Bylong Coal Project

Response to Submissions on Groundwater

Prepared for
Hansen Bailey Pty Ltd

Simulated and observed groundwater levels north - alluvium (layer 2) - December 2015

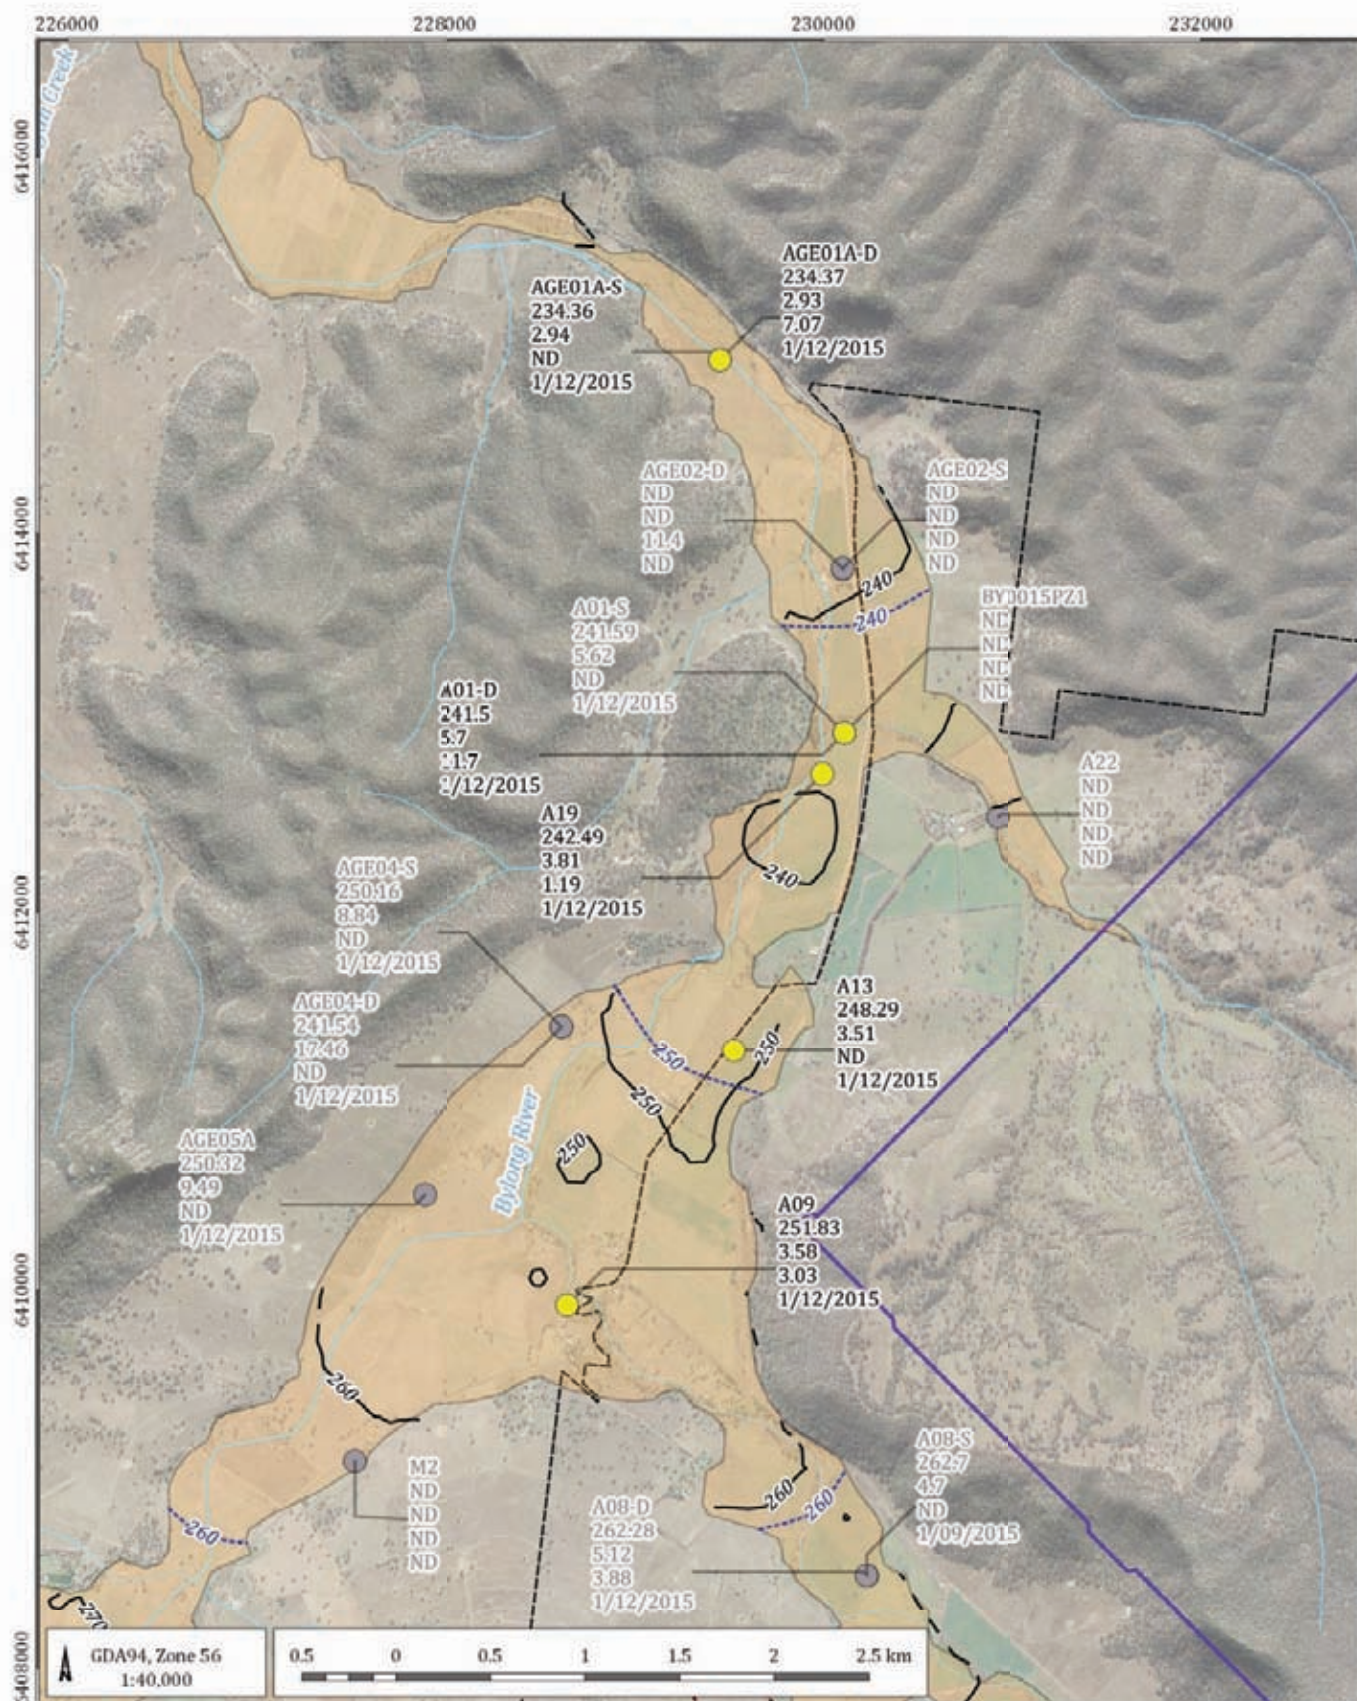
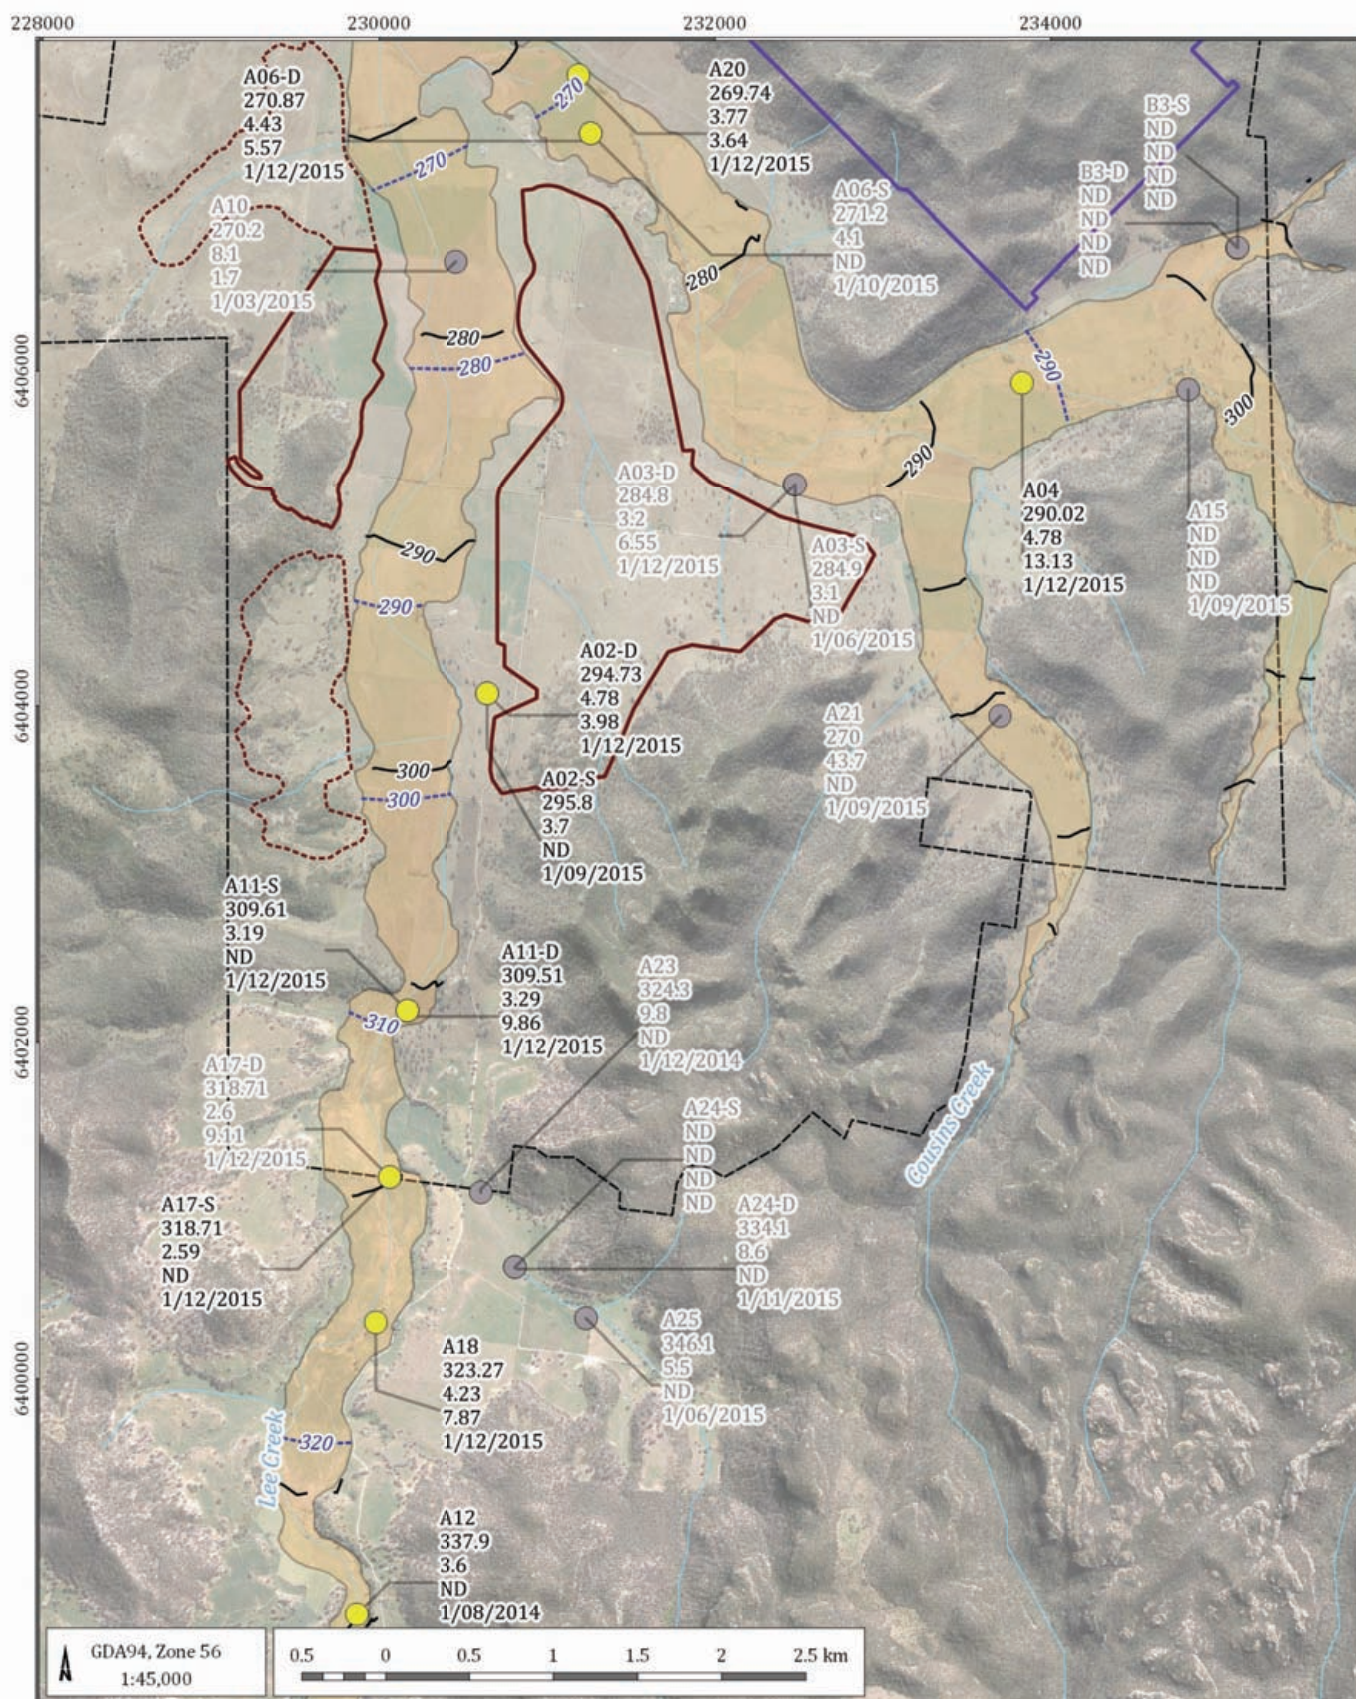
Stakeholders requested groundwater level outputs from the model for layers between the alluvium and Coggan Coal Seams, to allow comparison with the conceptual contour maps (contained within Section 4) generated from the raw data. Figure 28 to Figure 37 display the measured and simulated groundwater levels for December 2015 for the key layers within the model as follows:

When using MODFLOW USG the water level contours for each layer only show groundwater levels in the areas where each of the geological units represented by the model layer are present. The predicted groundwater levels correlate well with the measured groundwater levels within layer 2, which represents the alluvium. The water levels within layers 3 to 9 show the groundwater model represents an elevated head within the hills overlying the proposed underground mining area, and a general decline in head in the deeper layers towards the coal seam.

The model approximates the potentiometric surface measured within the Coggan coal seam and the underlying Marrangaroo Formation. However, there is a systematic over prediction of groundwater levels, particularly in the southern areas of the Project, and in the bedrock hills. The match between observed and predicted is more closely correlated in bores installed under the alluvial flood plain, presumably due to the boundary condition effect of this feature on underlying strata. Figure 31 which represents the Wallerawang Subgroup does not show a good match between the location of the formation and the location of the monitoring bores and indicates further interpretation on the geological formations in these areas is required. Section 7.2.5 describes further geological modelling to be undertaken during development of the Water Management Plan to better define the geological surfaces, and the formations within which new and existing bores are installed.
